VILLAGE BOARD AGENDA

- b. First Amendment of Development Agreement- Footworks Dance Company
 - c. Change Request #6 to SMA Construction Services in the amount of \$-10,458.00 for the Kimberly Street & Parks Dept. Building

- d. Change Request #7 to SMA Construction Services in the amount of \$9,954.32 for the Kimberly Street & Parks Dept. Building
 - e. Application for Temporary Class "B" Beer license- Kimberly Baseball Organization for Sunset Classic Tournament June 20-22, 2025 (Danielle Eckes, Agent)

P402

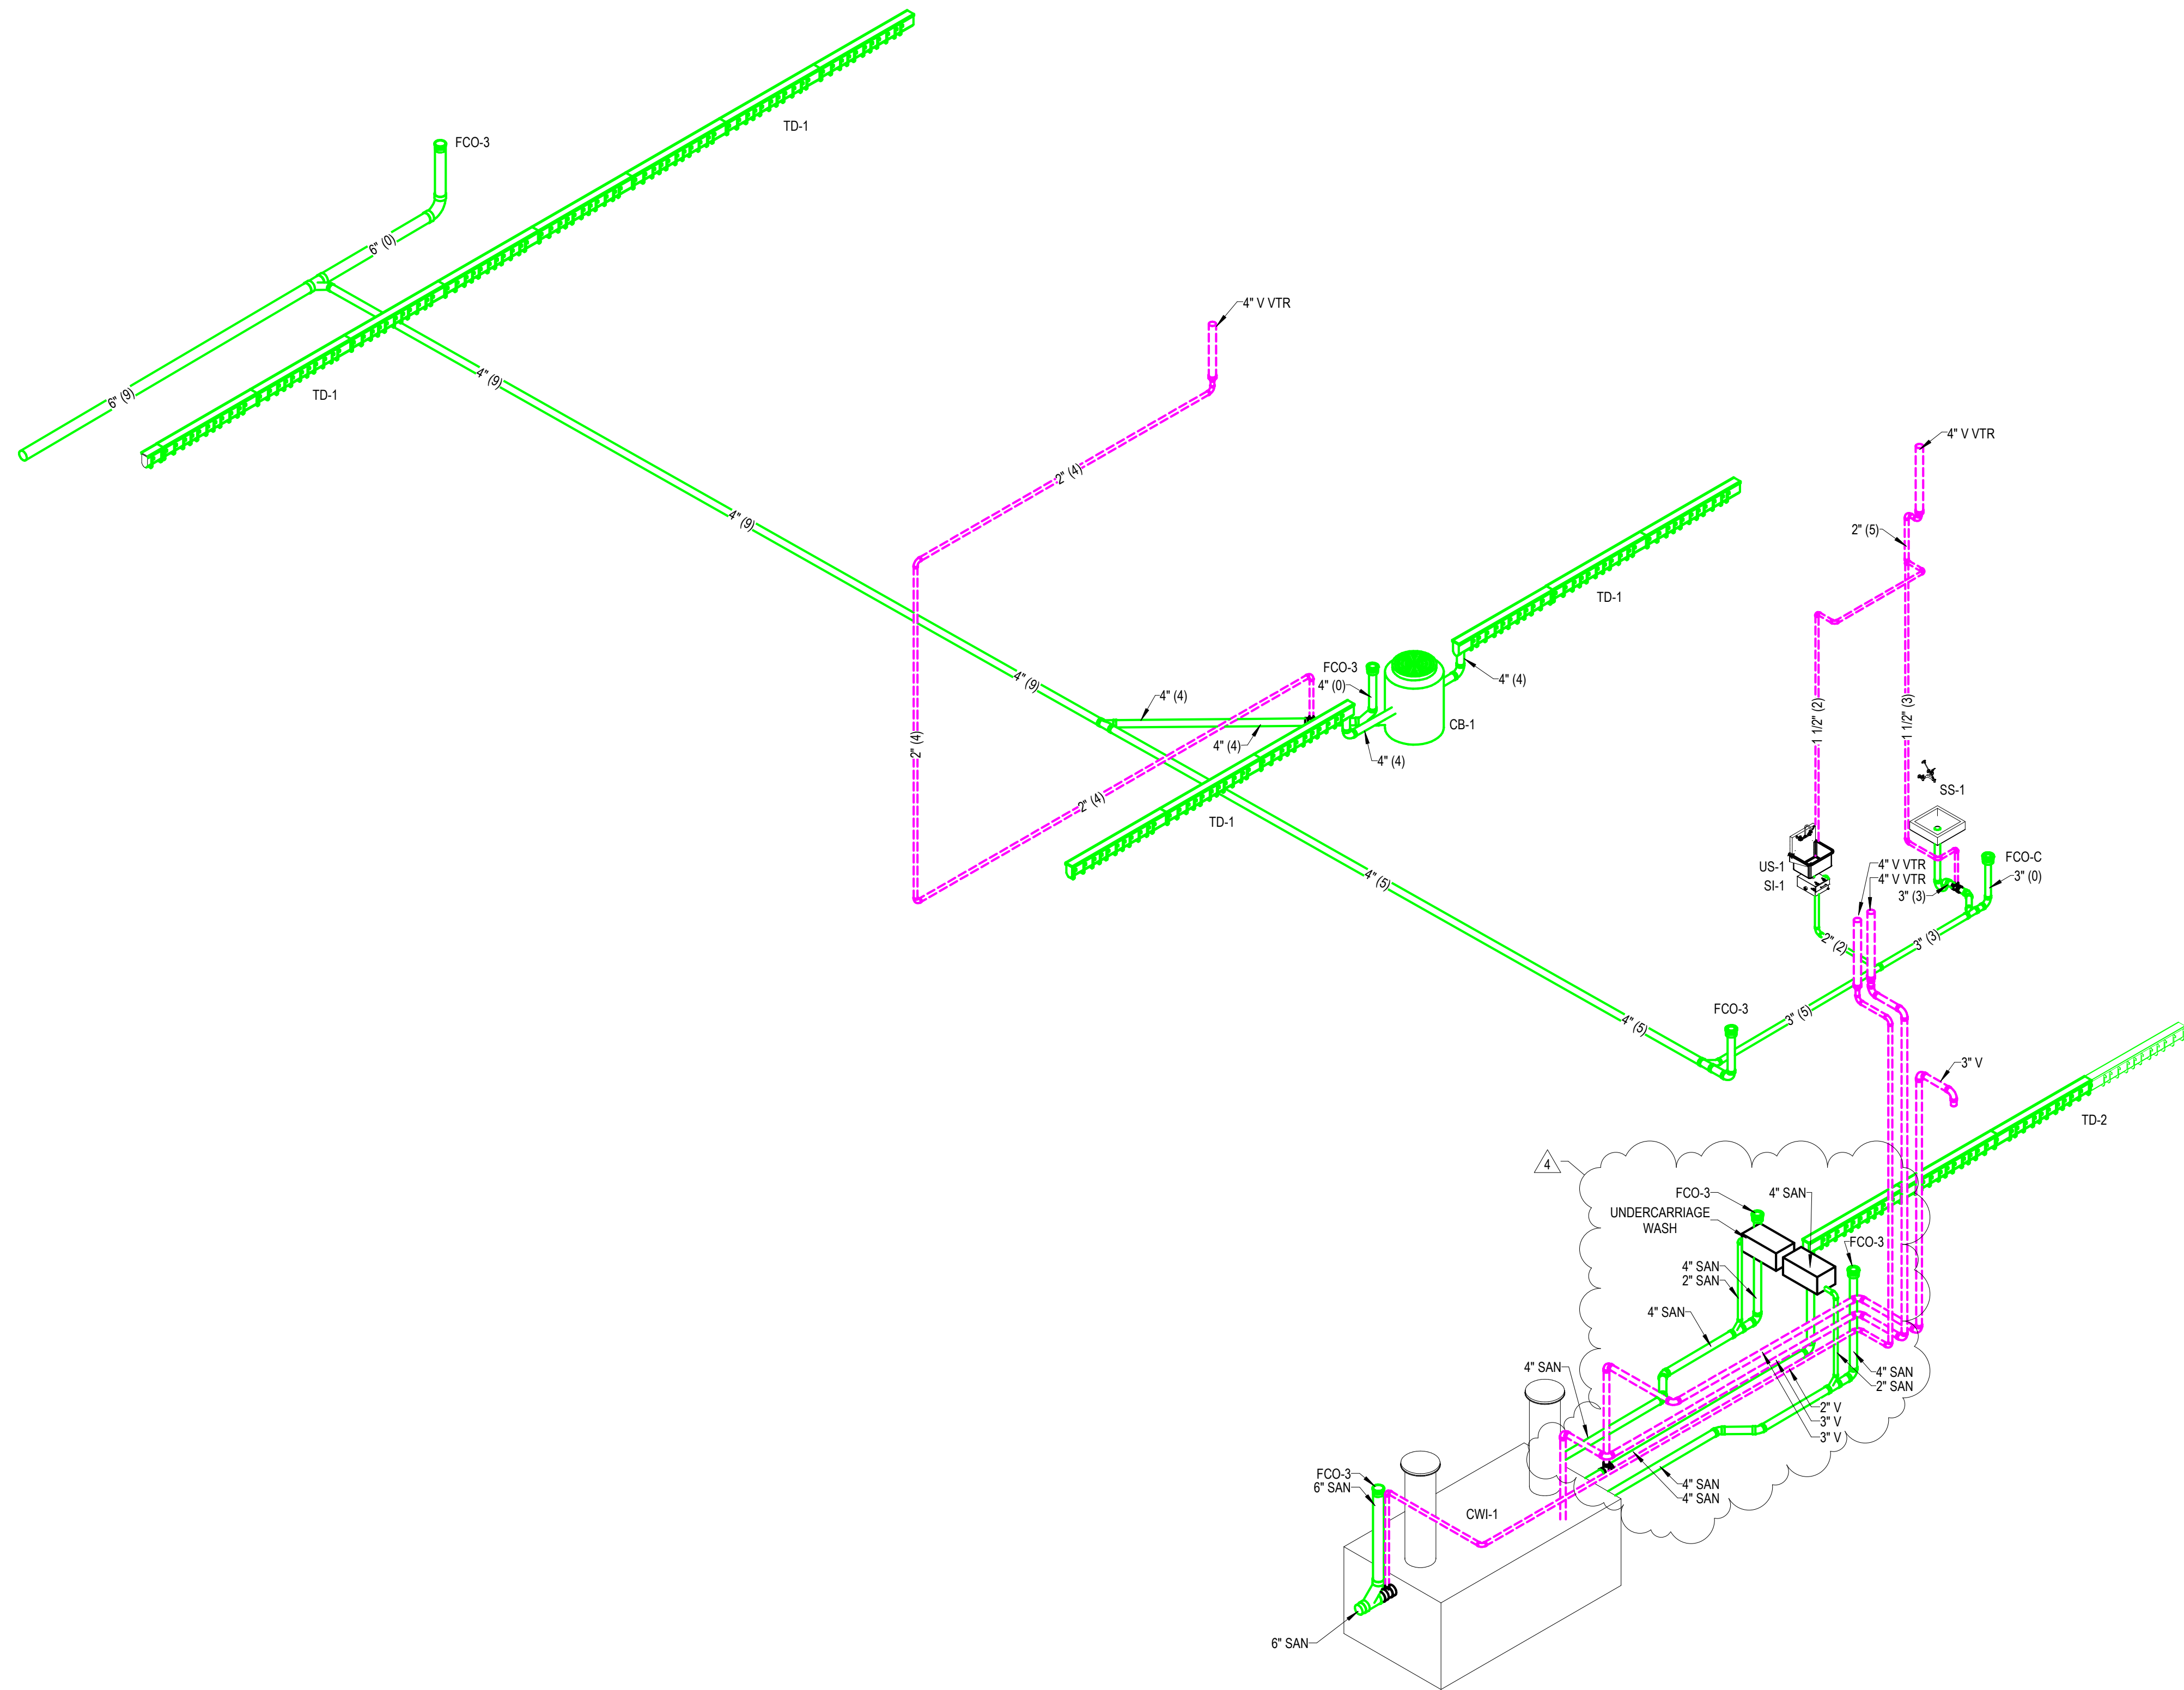
- With revised location of undercarriage wash boxes at 9'-2" from inside of OH door it puts the scheduled TD in conflict. A narrower drain would be a very tight fit and would likely result in re stocking fees of new 4" drain. Discussion led to an agreement to shorten existing TD to avoid conflict with boxes.
- See attached plan sheets depicting UG plumbing vs. what equipment manufacturer has listed on documents supplied to us. Looking to verify changes in contract drawings for equipment installation - See EGI Attachment for further reference.

6" cleanout access is required at change of pipe size to the 2" drain connections at UC Wash Equipment therefore we need to install 6" x 2" reducing wyes and add 6" floor cleanout at end of each branch. If the 4" referenced at Note #128 applies we should install 4"x 2" at connections and 4" floor cleanouts. This would be more economical.

P102

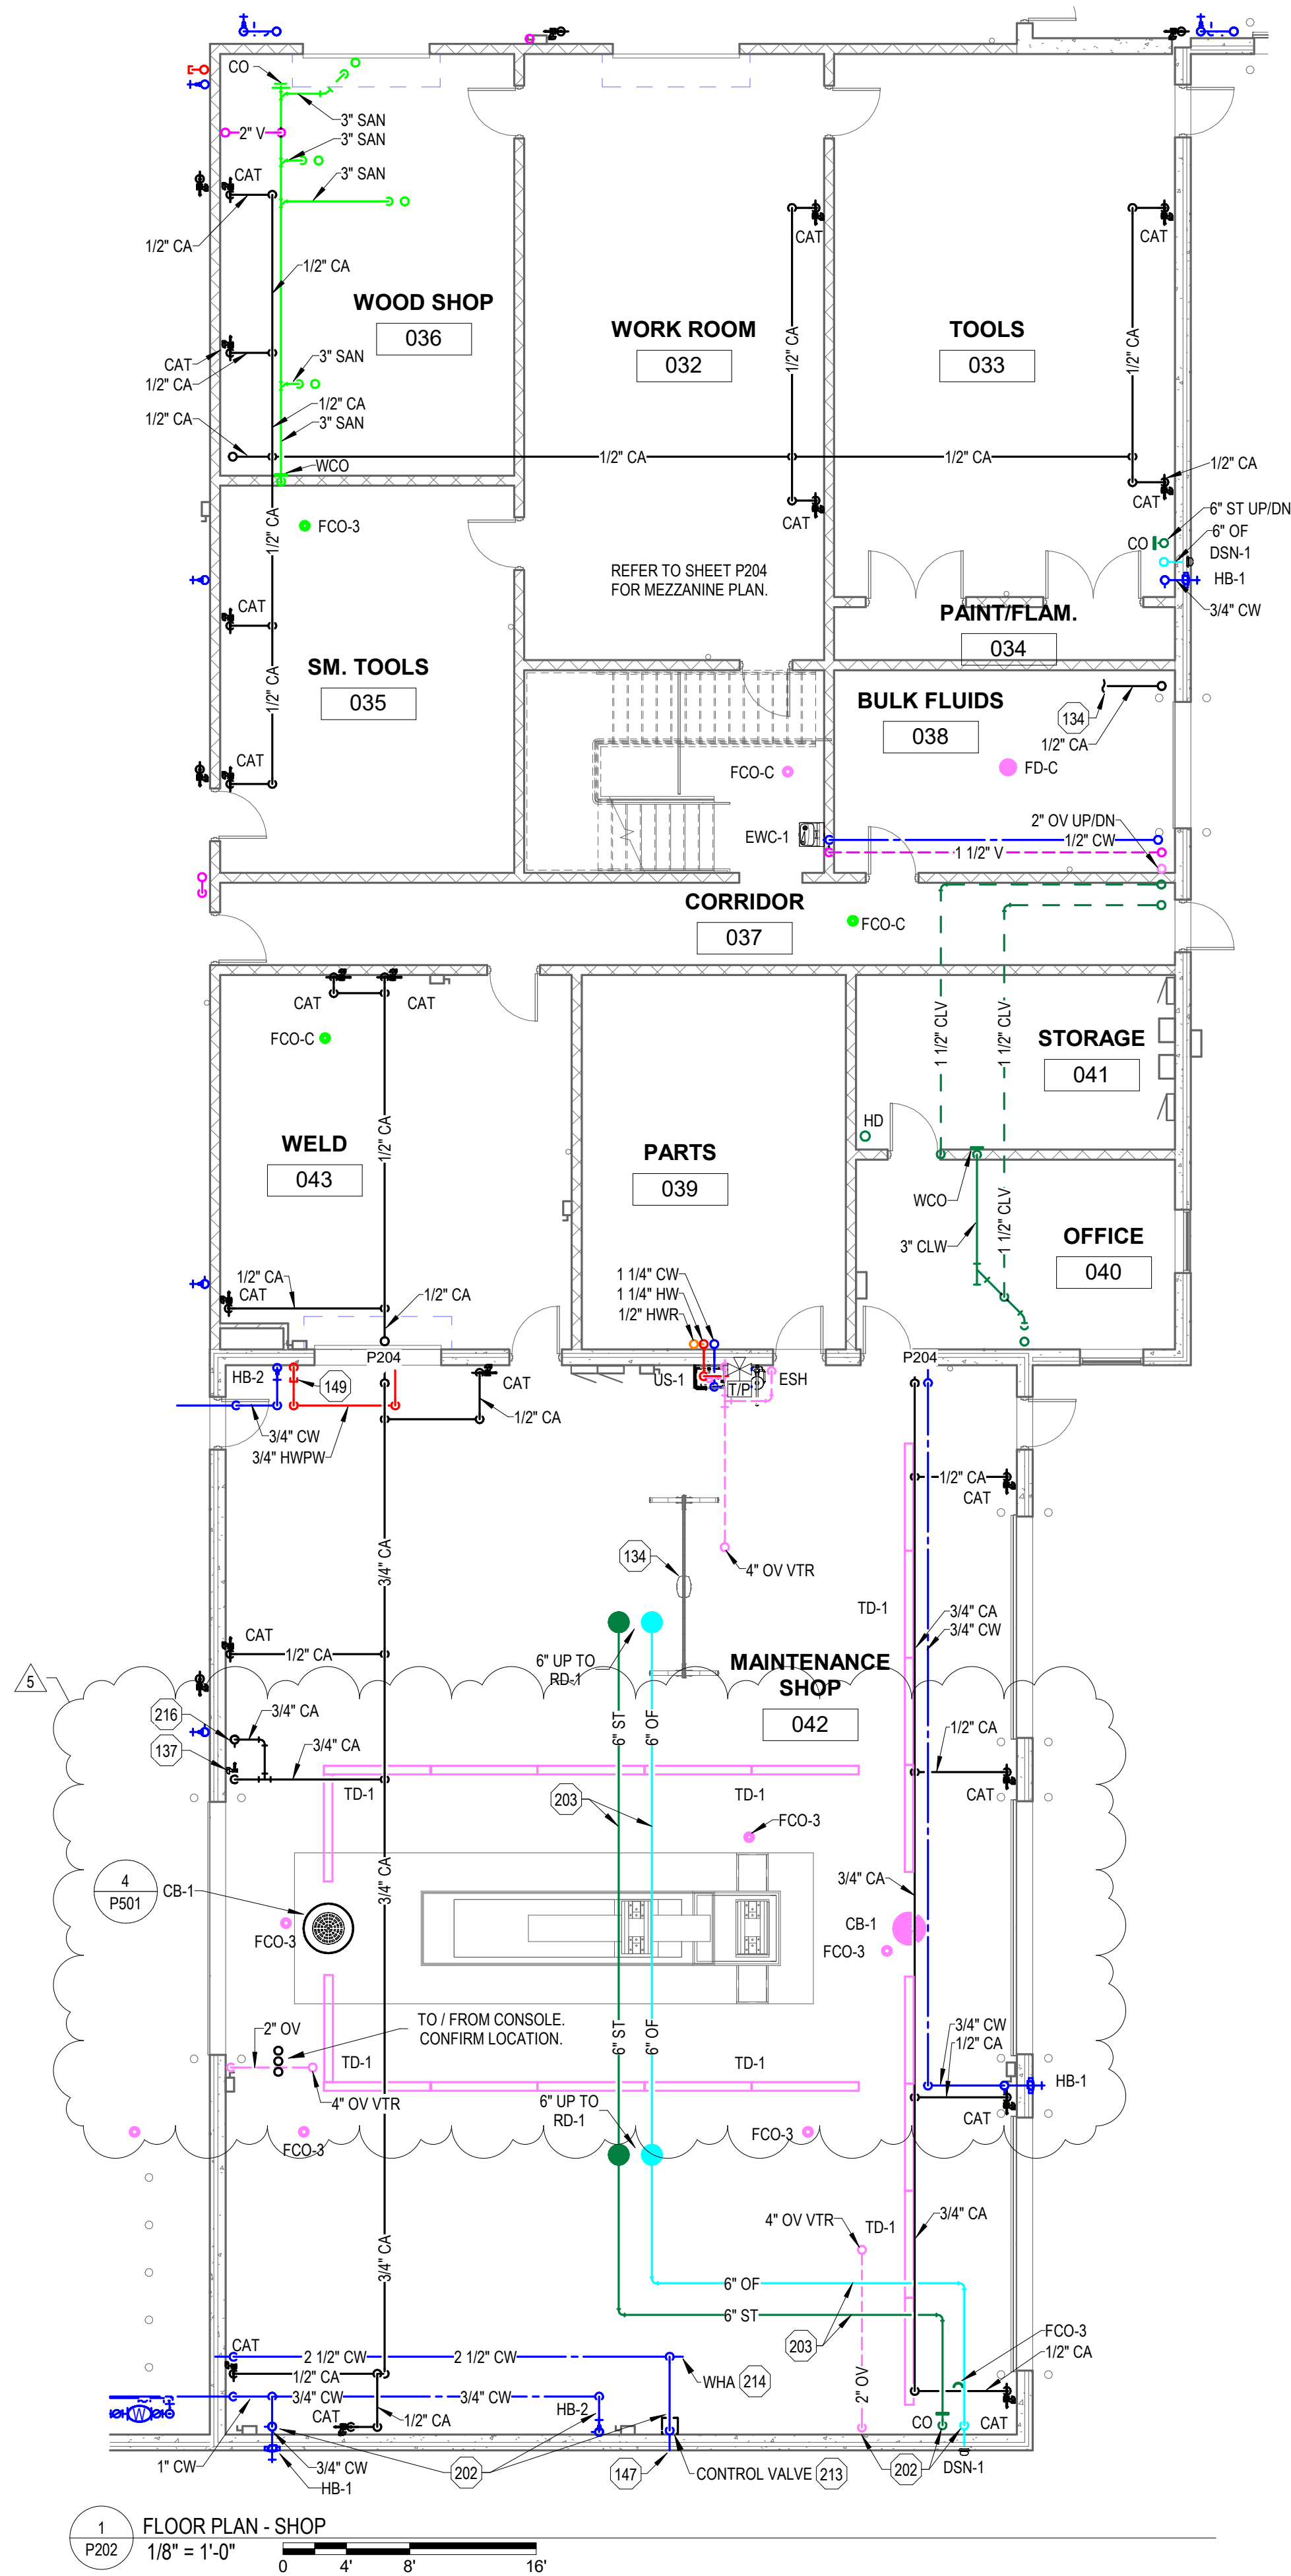
Drawings P102/P412 show a 4" Gravity OW line from catch basin to bottom of Pit. EcoLift equipment drawings show sloped base to Sump Pit and Pump.

- 1) Is the 4" gravity drain required?
- 2) Plumbing drawings do not show the discharge line from pump at Page 6 of 7 - please provide size and connection point to OW system.
- 3) P102/Note 137 states valve and cap at 4' AFF. Ecolift drawing 5 of 7 shows Filter/Regulator/Lubricator (by others). Whom shall furnish this equipment? If EGI, can you please provide specifications.
- 4) P202/Note 137 - Can the 3/4" CA drop be relocated to East side of door to be adjacent to Control Console? Pending confirmation on location of Console.
- 5) Drawing set indicates (1) 2" sleeve from before mentioned 3/4" CA drop to Control Console. Ecolift drawings show (2) additional 4" SCH40 PVC chase runs and potential sleeve for CA to sump pit pump. Please confirm EGI shall install the additional 4" and CA to pump sleeving. CA line size to pump also. Thank you.
